SERVICE BULLETIN

Reference:	342-49-049 – SERVICE BULLETIN
Title:	Update of removal and installation procedures following the release of SB 342-49-048
Issue number:	001
Issue Date:	27-apr-2023

This Service Bulletin (SB) is applicable to all APU power plant fitted on Leonardo Helicopters AW189/AW149 helicopters.

Some procedures need to be updated with regard to the new combustor casing design, which modified the locking of the ignition and main manifolds' burners, igniter plugs and drain valve. The impacted procedures, updated in this Service Bulletin, are the following:

Figure 1: Ignition manifold - Remove procedure (pre-modification SB 342-49-028 configuration)

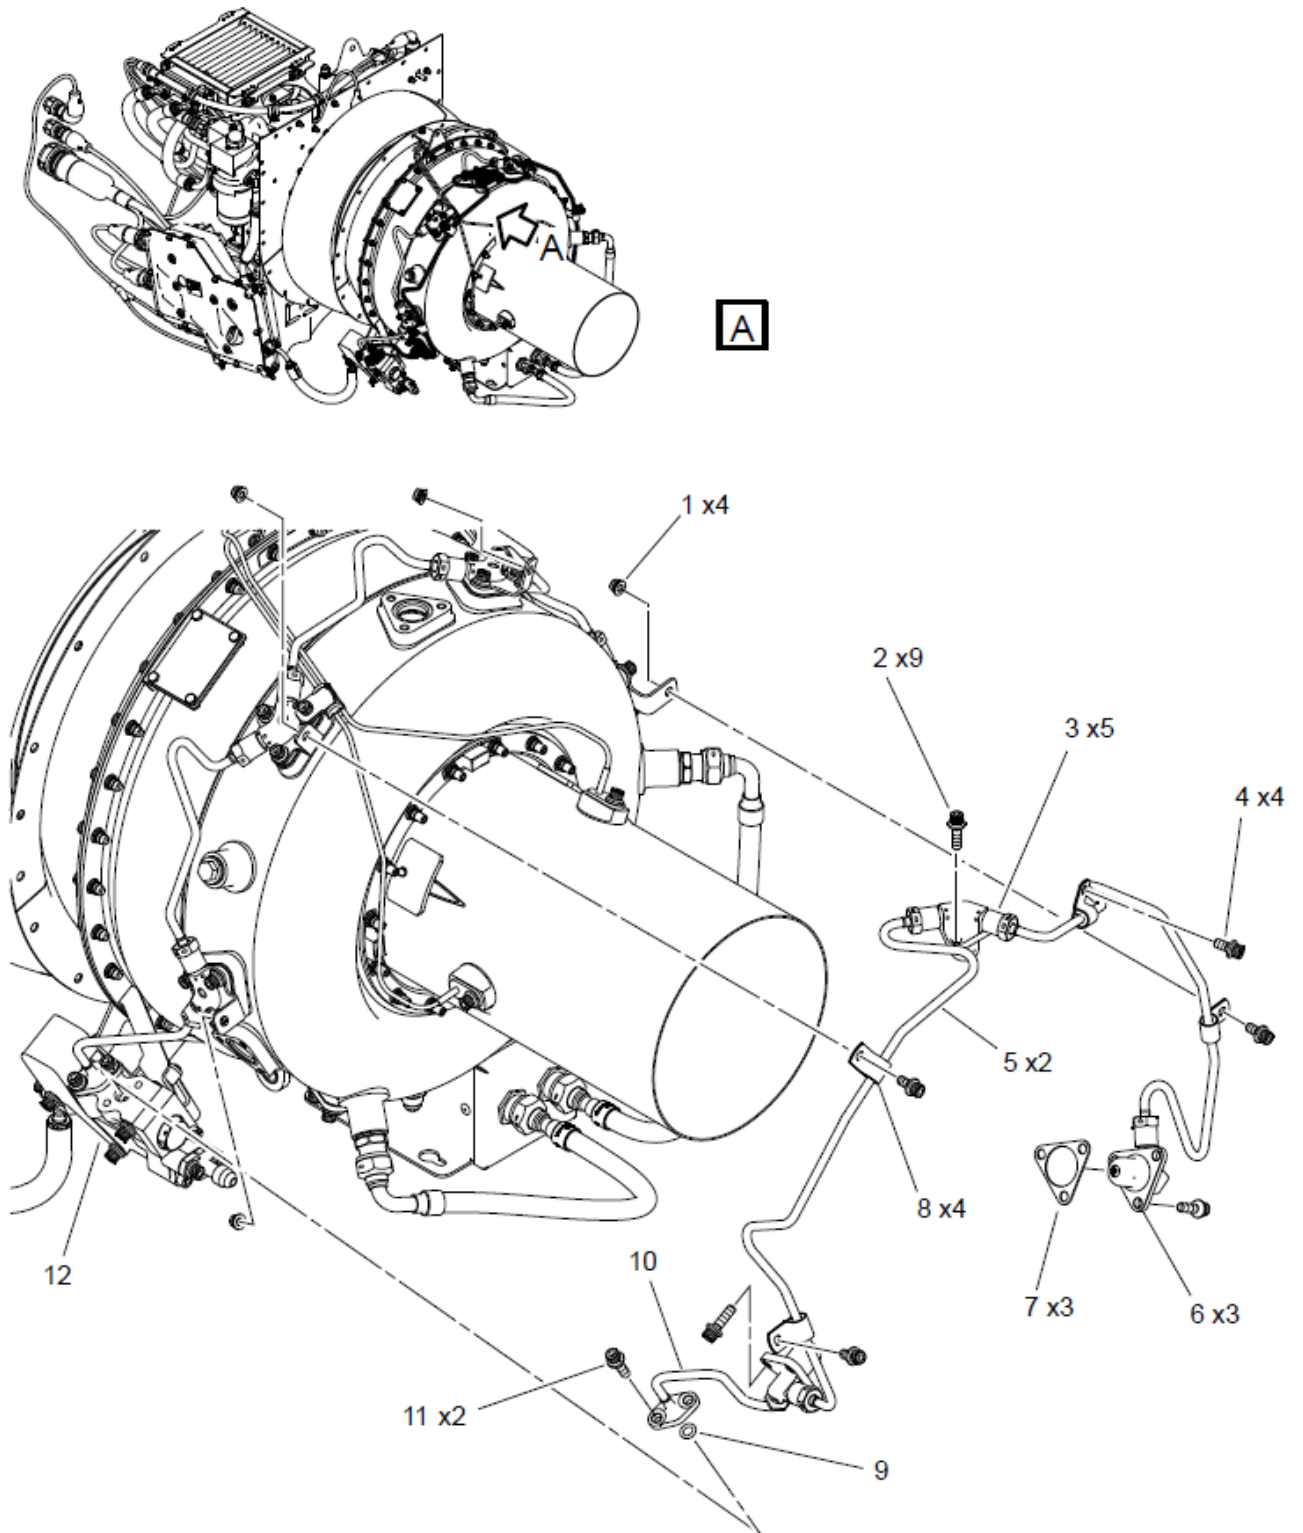
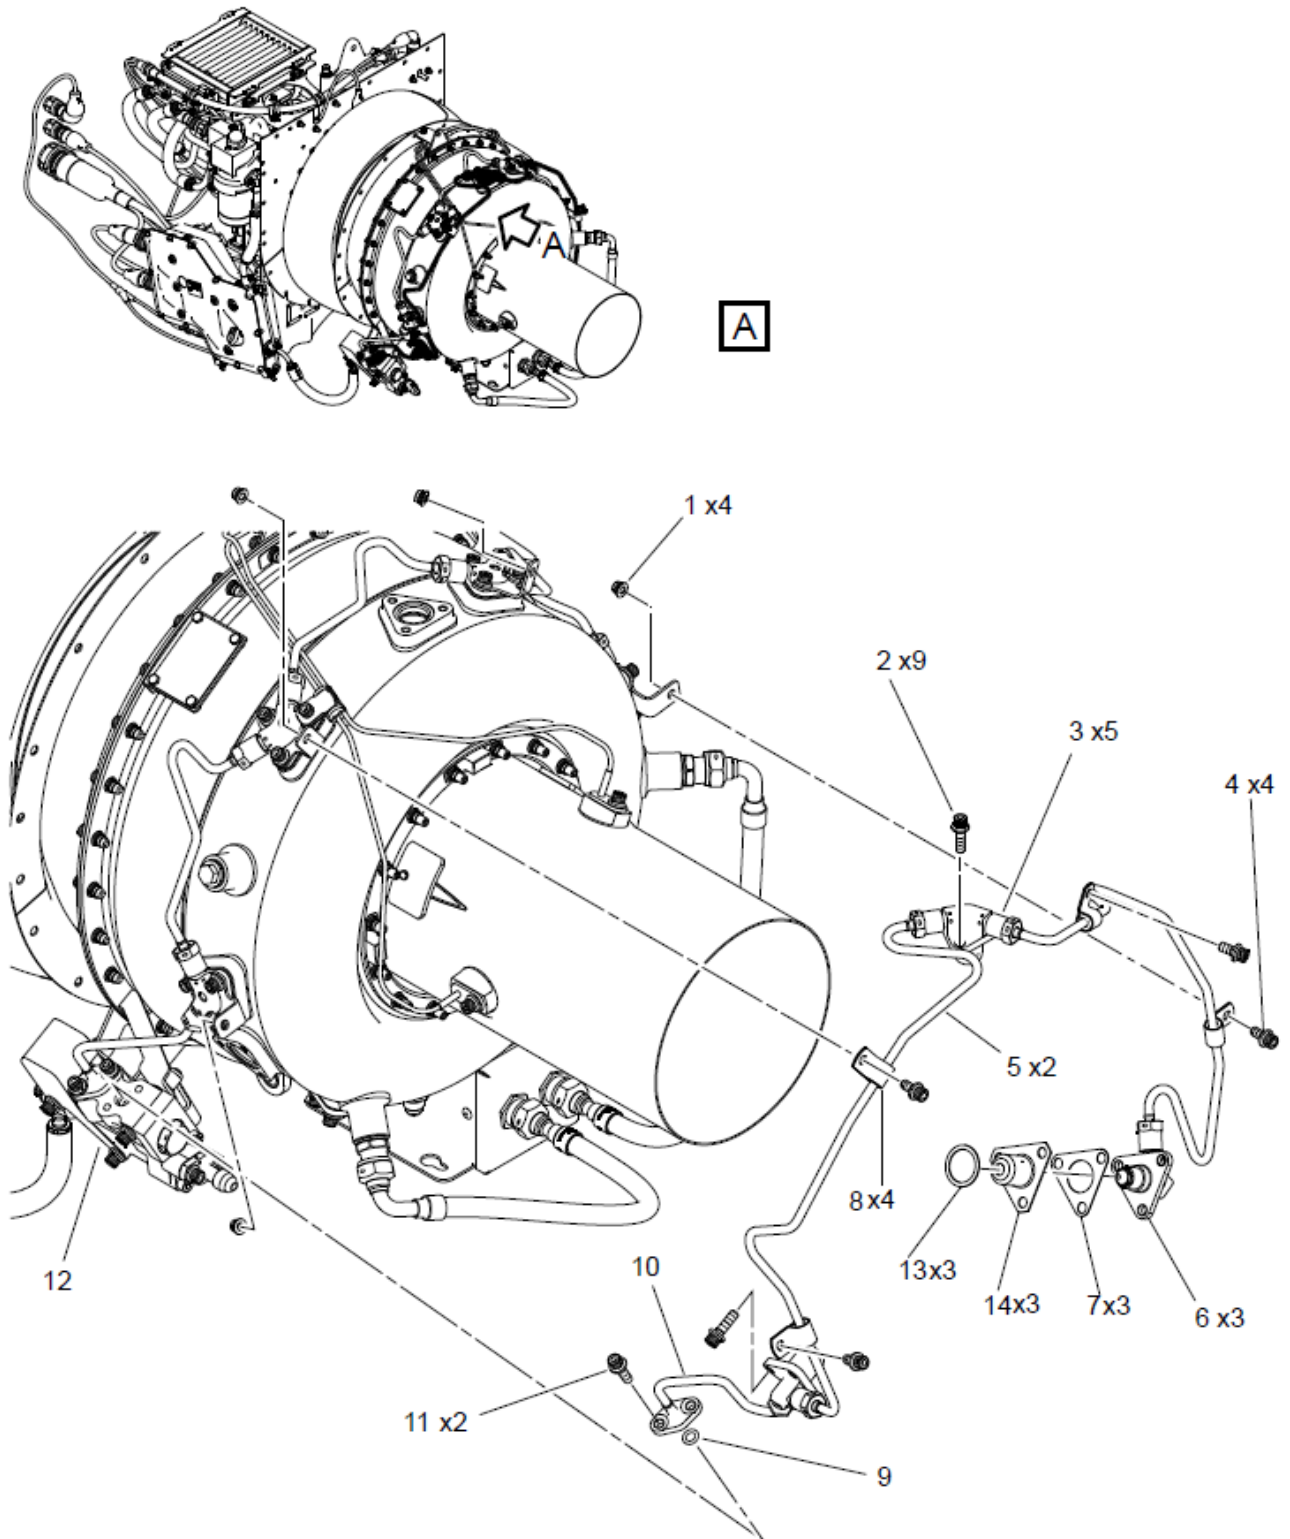
3. Removal of the ignition burners if the APU is a post-modification SB 342-49-048 configuration:

Cut and remove the safety wire from the three ignition burners (6).

4. Unscrew the five nuts (3).
5. Remove the two fuel lines (5).
6. Remove and discard the two screws (11) of the fuel lines (10) on the drain block (fuel flow divider) (12).
7. Remove the fuel lines (10) from the drain block (fuel flow divider) (12).
8. Remove and discard the O-ring (9).
9. Install four Protective plugs on the fuel lines (5).
10. Install one of the Protective plugs and the Protective cap on the fuel lines (10).
11. Removal of the ignition burners if the APU is a pre-modification SB 342-49-028 configuration.
 - 11.1 Remove and discard the nine screws (2) of the three burners (6).
 - 11.2 Remove the three burners (6).

- 11.3 Remove and discard the three seals (7).
- 11.4 Install six Protective plugs on the burners (6).
- 12. Removal of the ignition burners if the APU is a post-modification SB 342-49-028 configuration.
- 12.1 Remove and discard the nine screws (2, Figure 2) of the three burners (6).
- 12.2 Remove the three burners (6).

- 12.3 Remove and discard the three seals (7, Figure 2).
- 12.4 Remove the three caps (14, Figure 2) equipped with the three seals (13, Figure 2).
- 12.5 Remove and discard the three seals (13, Figure 2) from the three caps (14, Figure 2).
- 12.6 Install the six protective plugs on the burners (6).

Figure 3: Ignition manifold - Installation procedure (pre-modification SB 342-49-028 configuration)

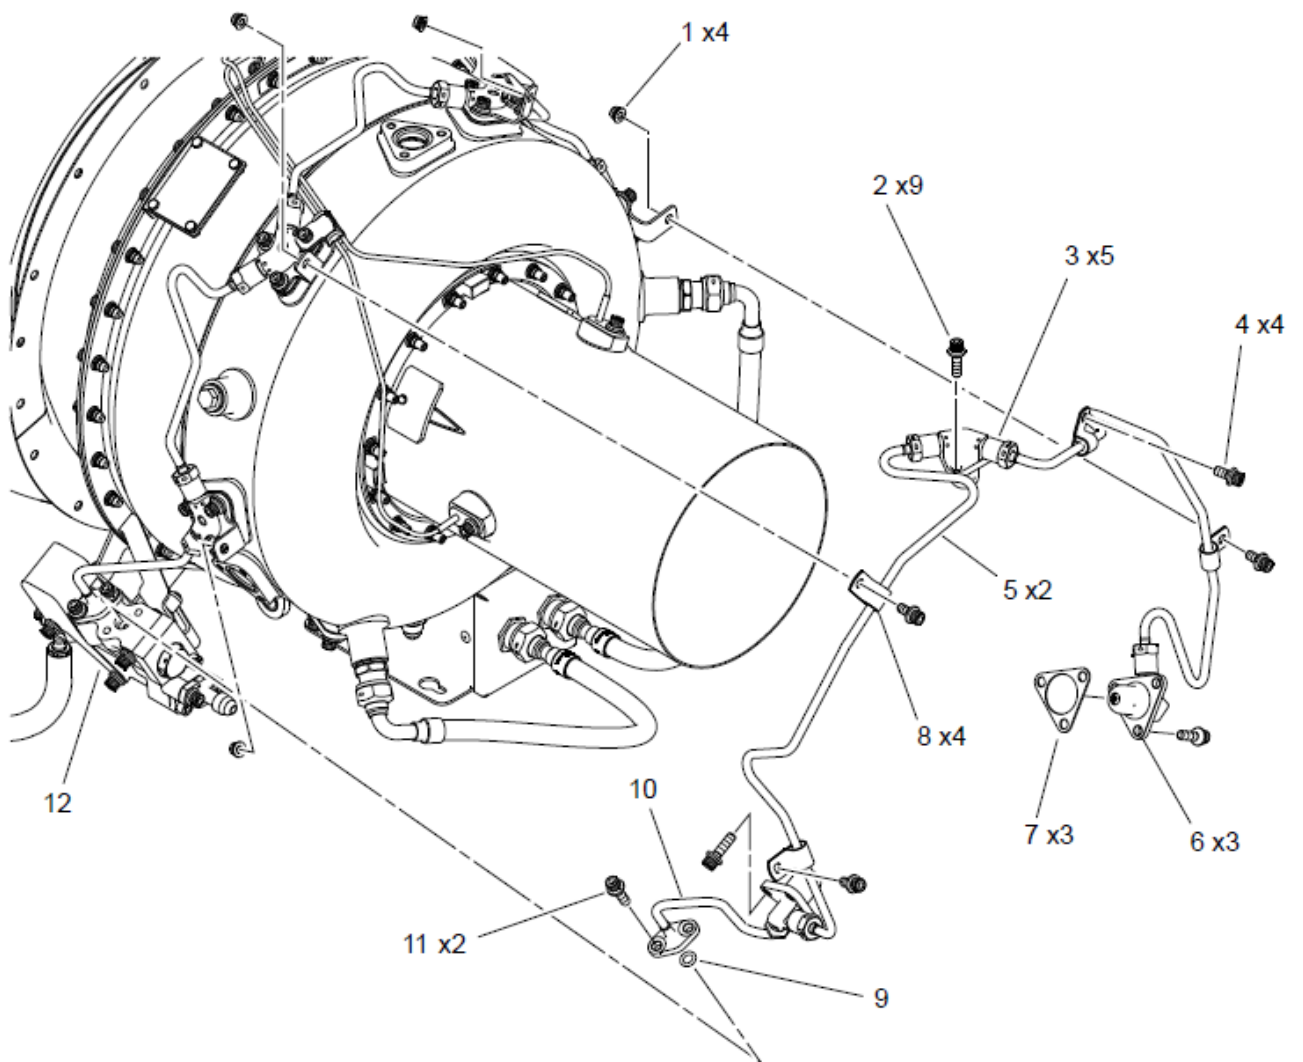
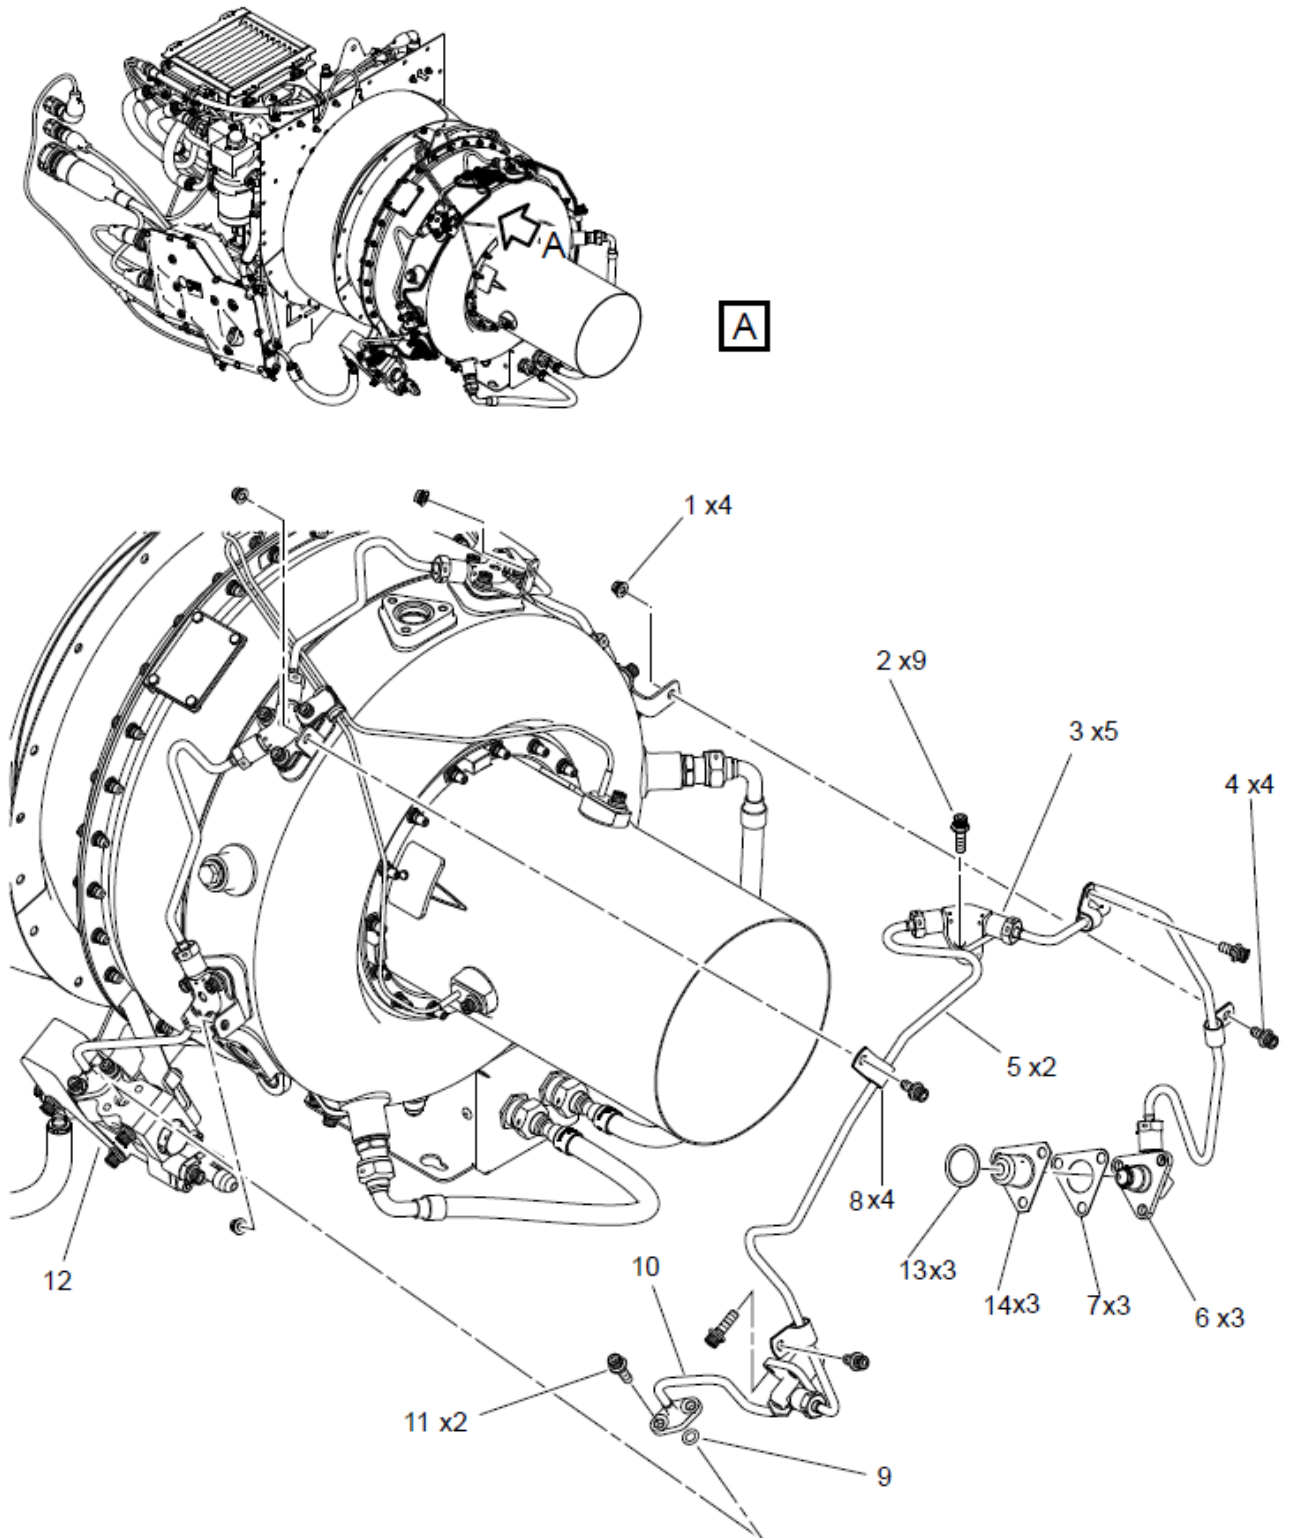
2. Remove the six protective plugs from the three Burner (6, Figure 3).

3. Installation of the ignition burners if the APU is a pre-modification SB 342-49-028 configuration:

3.1 Install the three Caps (493000-01-053) and the three new Seals (7) on the three Burner (6).

3.2 Install the three burners (6) on the combustor casing.

4. Installation of the ignition burners if the APU is a post-modification SB 342-49-028 configuration:

4.1 Install the three new Seals (7, Figure 4) on the three burners (6, Figure 4).

4.5 Install the three burners (6, Figure 4) equipped with the three new seals (7, Figure 4) and the nine new Screws (2, Figure 4) on the combustor casing.

Figure 6: Locking of the Screws (2) (post-modification SB 342-49-048 configuration)

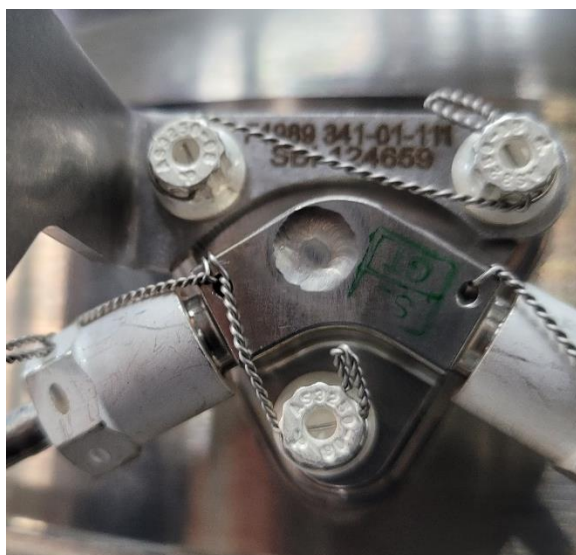
23. Installation of the ignition burners if the APU is a post-modification SB 342-49-048 configuration:

23.1 Lock the nine new Screws (2) with Lockwire as shown in the Figure 6.

Figure 7: Burner manifold - Remove procedure

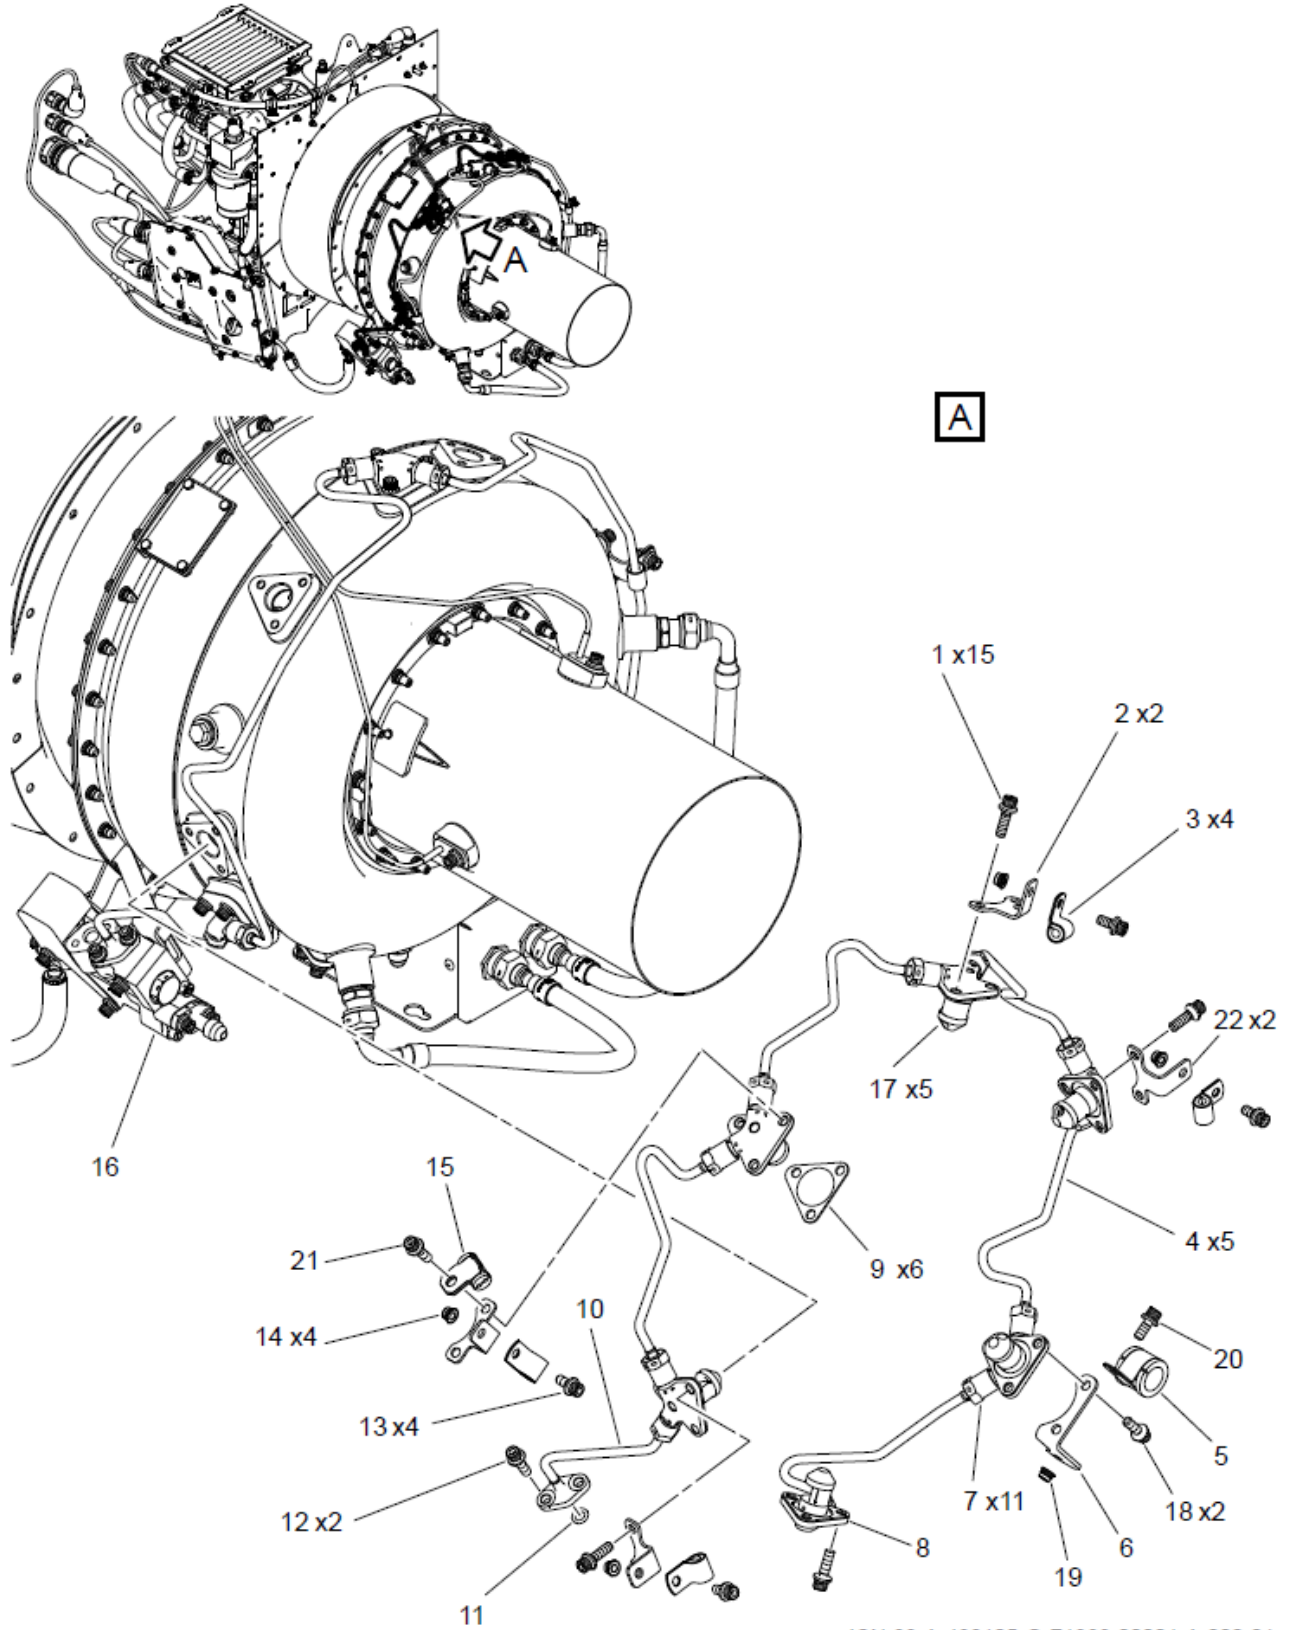
1. **CAUTION**
Be careful when you cut and remove safety wire. Safety wire can cause injury to persons.
 Cut and remove the safety wire from the 11 burner manifold nuts (7, Figure 7).

2. Removal of the main burners if the APU is a post-modification SB 342-49-048 configuration:
 - 2.1 **CAUTION**
Be careful when you cut and remove safety wire. Safety wire can cause injury to persons.
 Cut and remove the safety wire from the six main burners (8, 17).

11. Remove and discard the 18 screws (1, 18, 21) of the six burners (8, 17).
12. Remove the six burners (8, 17) with the five brackets (2, 6, 22) and the bracket (15).
